**UNITED STATES OF AMERICA
BEFORE THE
DEPARTMENT OF ENERGY**

Energy Conservation Program: Energy	)	EERE-2014-BT-STD-0031
Conservation Standards for Consumer	)	RIN 1904-AD20
Furnaces	)	87 Fed. Reg. 40590

**COMMENTS OF
THE AMERICAN GAS ASSOCIATION**

Dated: October 6, 2022

Figure 1: Market share of condensing furnaces vs. LCC savings

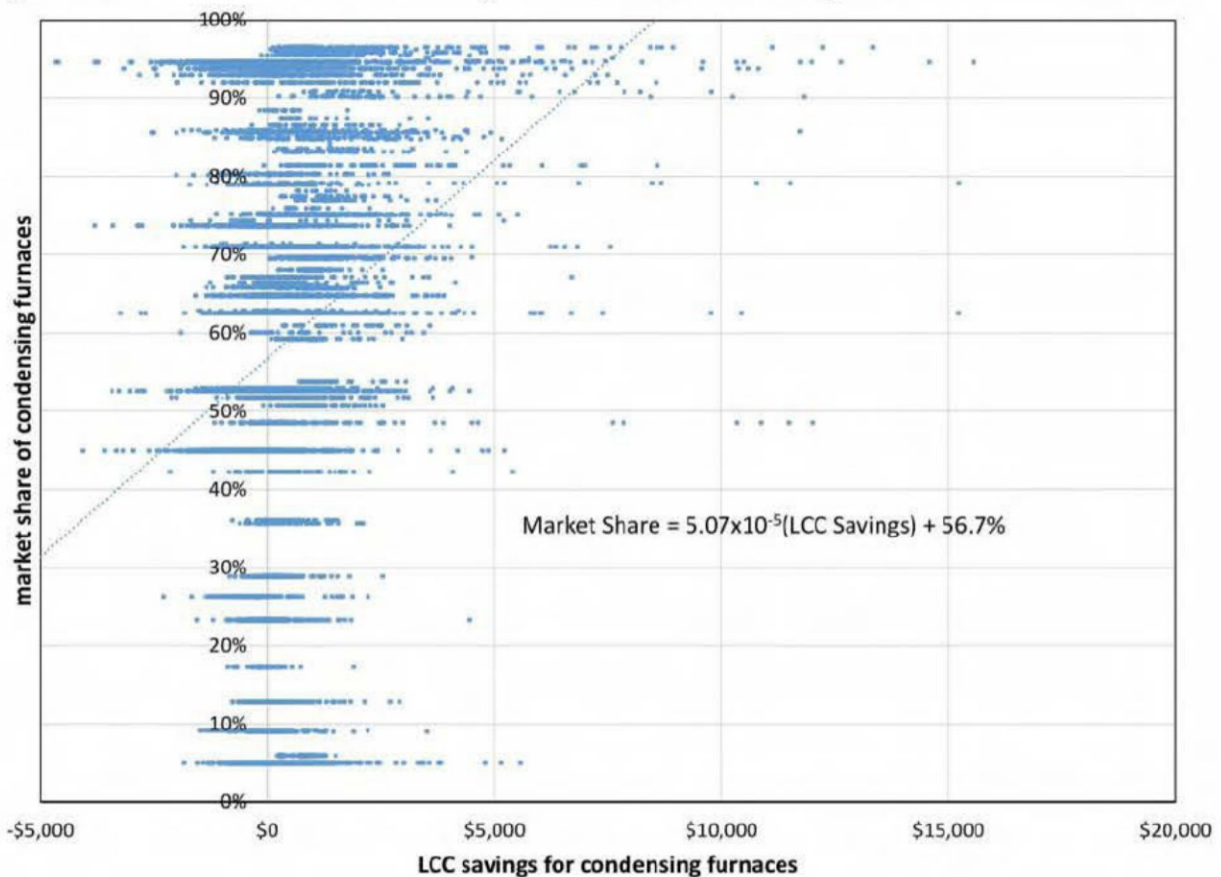
While there is a scatter in the data, this should be expected (the 10,000 trials contain different buildings, new and replacement furnaces, different incomes, *etc.*). The least squares best-fit line indicates a relationship between market share and LCC savings and that increasing LCC savings correlates with increasing market share. Further, the Pearson correlation coefficient between these variables is 0.243, with a p-value of 0.000. It is, therefore, more than 99.9% certain that these variables are positively correlated. Note also that the use of blended LCC savings is not necessary for a positive correlation; the Pearson correlation coefficient for condensing furnace market share for 90, 92, 95, and 98% AFUE LCC savings relative to 80% AFUE is 0.215, 0.228, 0.239, and 0.233 respectively, all have a p-value of 0.000. While this analysis is sufficient to prove beyond a reasonable doubt that the opportunity consumers have to save money relative to an 80%

Another interesting feature of Figure 1 is that the intercept of the y-axis is above 50%, meaning that the expected market share of condensing furnaces is above 50%, even if there is no economic incentive to install them. This suggests that if there is a market failure, according to DOE's LCC model, the market failure is that consumers choose more efficient products slightly more often than they should be based on economics alone.

Figure 2: Average LCC savings vs. market share of condensing furnaces for replacement applications

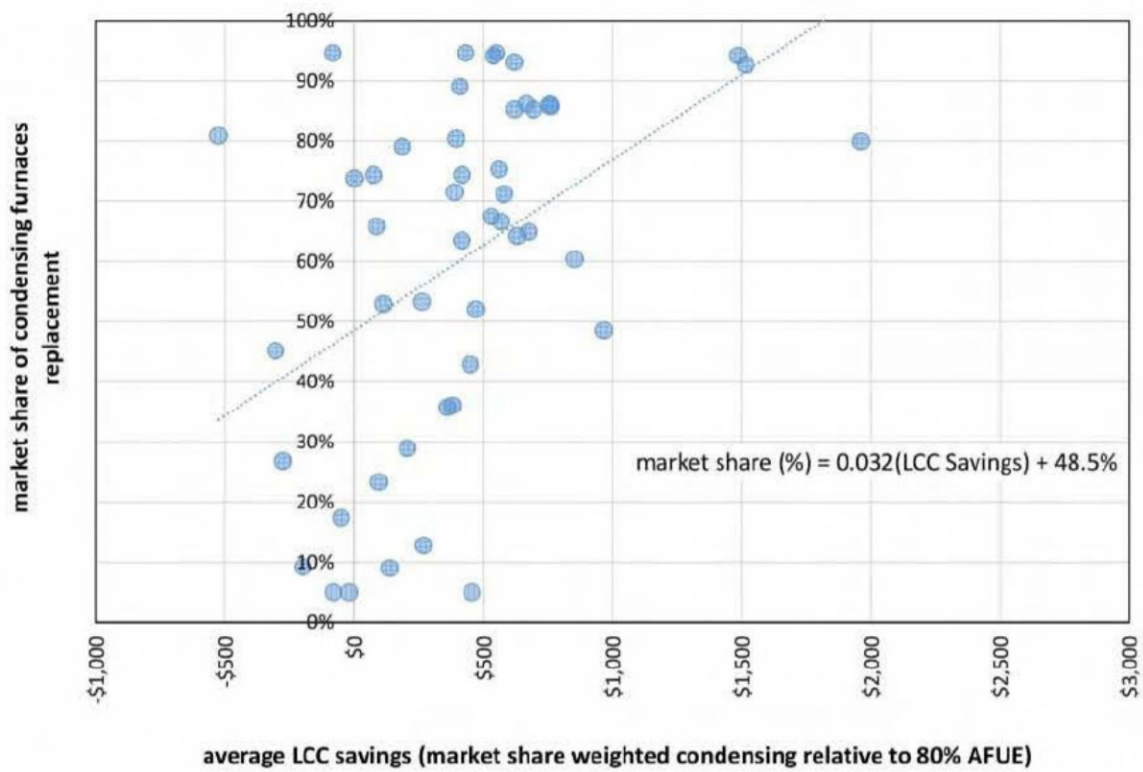
Figures 2 and 3 show the market share of condensing furnaces vs. average LCC savings with individual data points averaged by state. Again, there is a positive correlation between savings and market share in replacement and new construction applications. Unsurprisingly, in the case of new construction, LCC savings are higher, and there are no regions with a negative average LCC savings (because serious venting issues in new construction, designed for a condensing furnace, should never occur). Note that this portion of the analysis weights each region the same even though the number of data points between regions is not the same.

Figure 4: Percent of negative LCC outcomes for a 95% AFUE furnace relative to an 80% AFUE furnace vs. market share of condensing furnaces

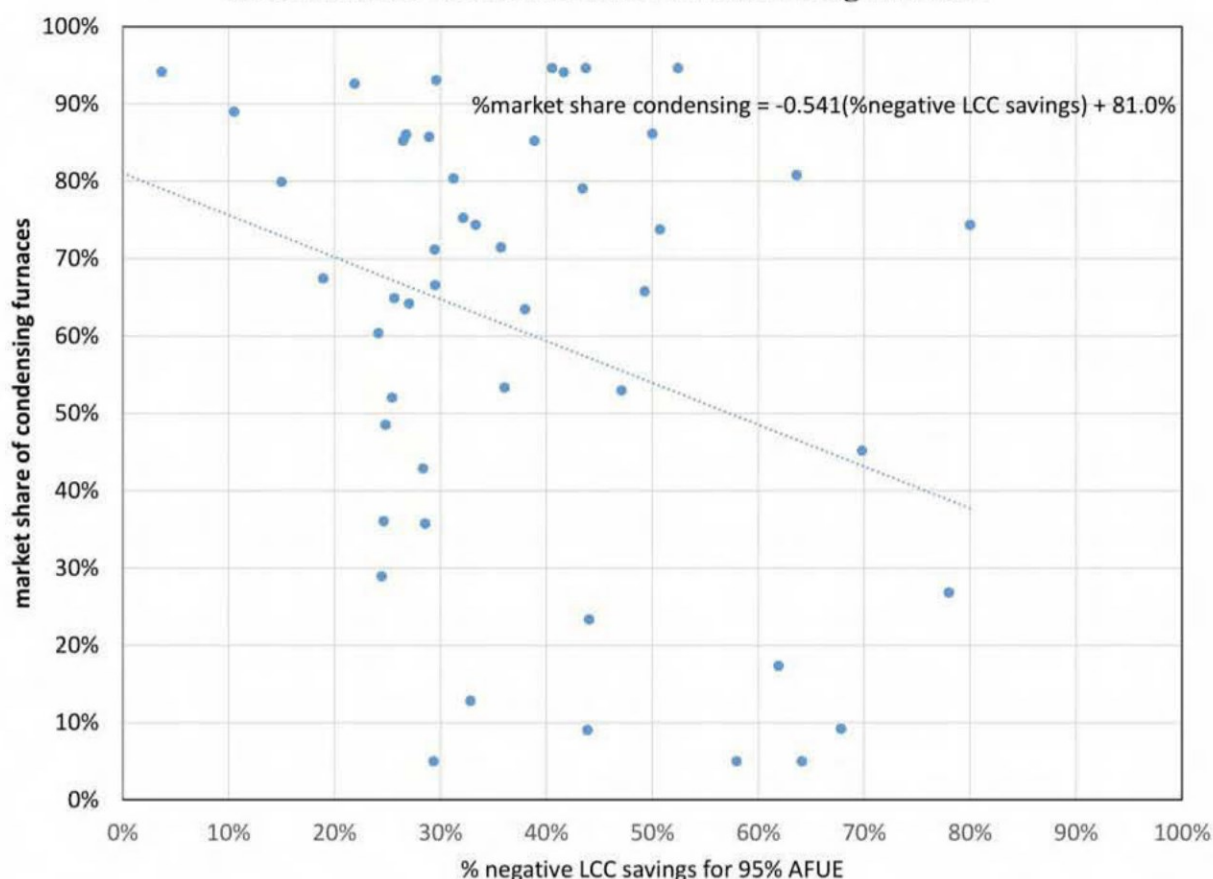
Percent of negative outcomes is another way to look at the data produced by this analysis. One would expect that if consumers were paying attention to economics, however imperfectly, there would be a negative correlation between the percent of negative LCC outcomes in a region and the market share in that region. If a large fraction of consumers experienced negative financial consequences from adopting condensing furnaces, one would expect that the market share of condensing furnaces in that region would be low. In this case, the analysis was limited to replacement situations as there are few negative outcomes in new construction situations. The Pearson correlation coefficient for the data displayed in Figure 4 is -0.321 with a p-value of 0.026, meaning that these data are negatively correlated with 97.4% certainty.

Figure 5: Percent of negative LCC outcomes for a 95% AFUE furnace relative to an 80% AFUE furnace vs. market share of condensing furnaces with “perfect” market line added.

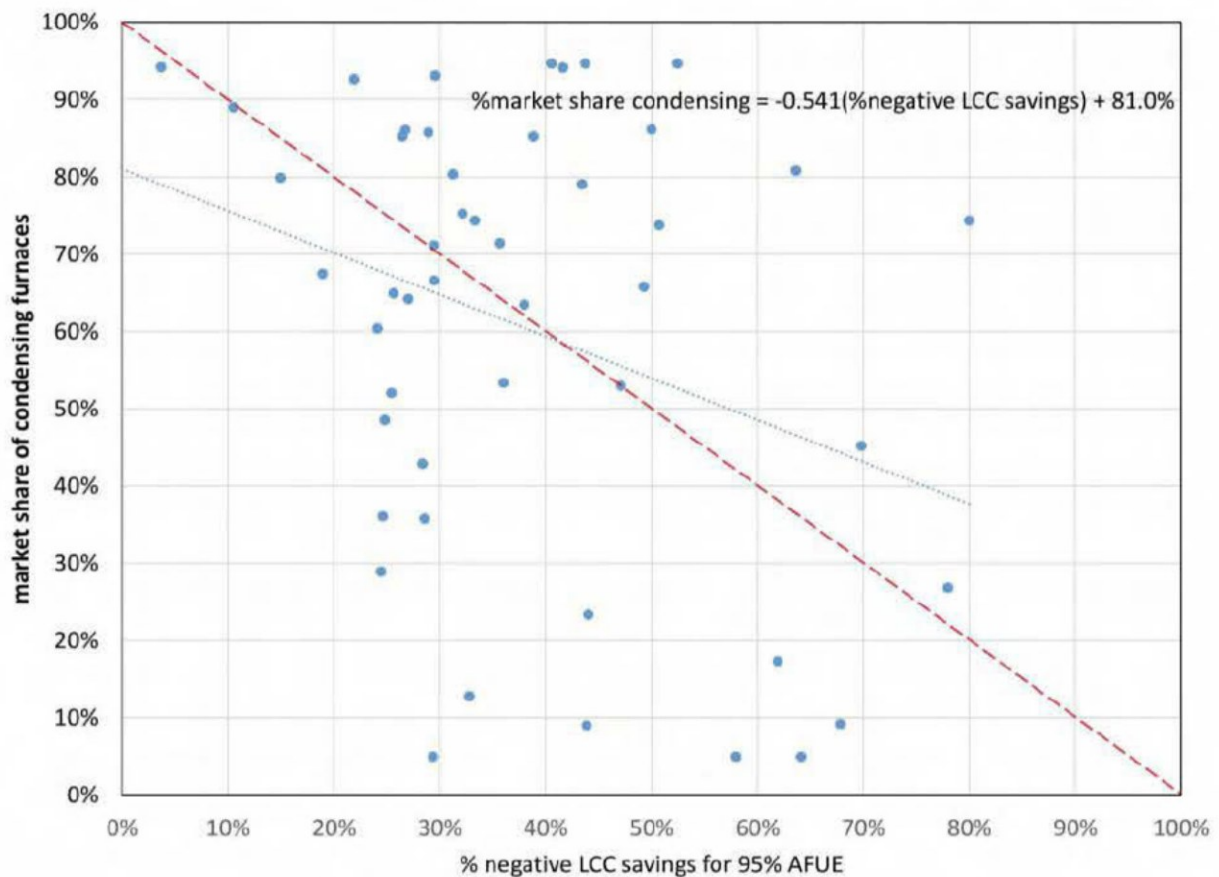
If consumers were perfectly assessing economic impact, all of the data points would fall on a line with 100% market share at 0% negative LCC outcomes and 0% market share where there are 100% negative LCC outcomes. Outcomes above the line indicate that the market share of efficient products is higher than it should be, and outcomes below the line indicate that the market share of efficient products is lower than it should be in a given region. Figure 5 shows this red line added to the prior Figure 4. There are 48 total data points on the graph, and 25 of them are above the line. These 25 points represent 53.6% of the underlying replacement trial cases. This shows again that if there is a systematic market error, the error is more likely that consumers are choosing overly efficient products than are economically justified than the opposite. However, on

the whole, it appears that consumers, on average, are doing an excellent job of assessing economics and choosing products accordingly.

Figure 10.2.1 Projection of No-New-Standards Case Efficiency Distribution for Non-Weatherized Gas Furnaces, 2029-2058

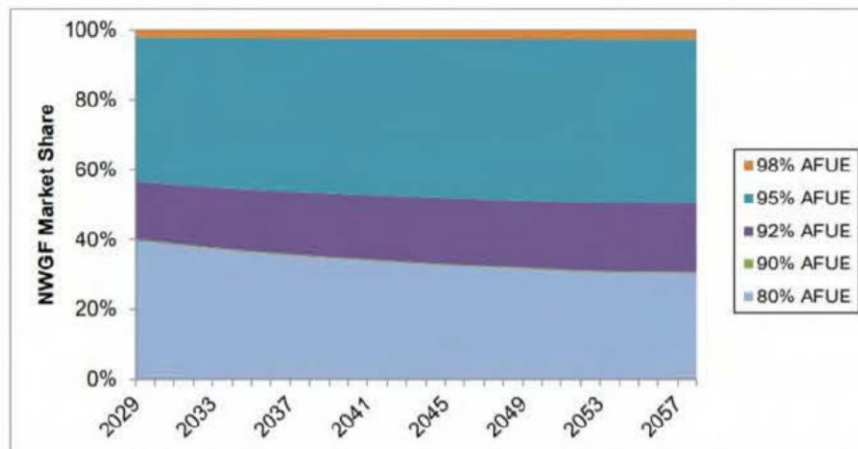
This is not only contrary to clear trends but also to DOE's assessment of the market in other parts of its Proposed Rule. DOE claims in the NOPR that "[f]or each considered efficiency level in each product class, DOE calculated the LCC and PBP for a nationally representative set of housing units and, for NWGFs, commercial buildings."¹²³ For example, DOE's TSD provided a forecast for each AFUE level through 2058. That forecast projected that non-condensing furnaces would lose 10% of the market (from 40% to 30%) for AFUE 80 furnaces between 2029 and 2058. Found in DOE's TSD, Section 10 Figure 10.2.1. But even that assumption is unreasonable. As noted above, AHRI's data showed that non-condensing furnaces lost 10% of the AFUE 80 market between 2006 and 2015. DOE does not explain why that trend would not continue over the next 10 years (i.e., 2015-2025) or why it is reasonable to expect a slowdown in the trend that would reflect a loss in market share of only 10% over 43 years (2015-2058).

In short, it is arbitrary and capricious for DOE to assume no change to the market for AFUE 80 furnaces in its LCC analysis. Even the Department's TSD suggests at least a 10% decrease in non-condensing furnace sales, and that number is unreasonably low because it fails to account for market trends. As with other aspects of the LCC analysis, DOE must revisit its unsupported assumptions about market share and replace them with data, assumptions, or estimates that are actually supported by evidence.
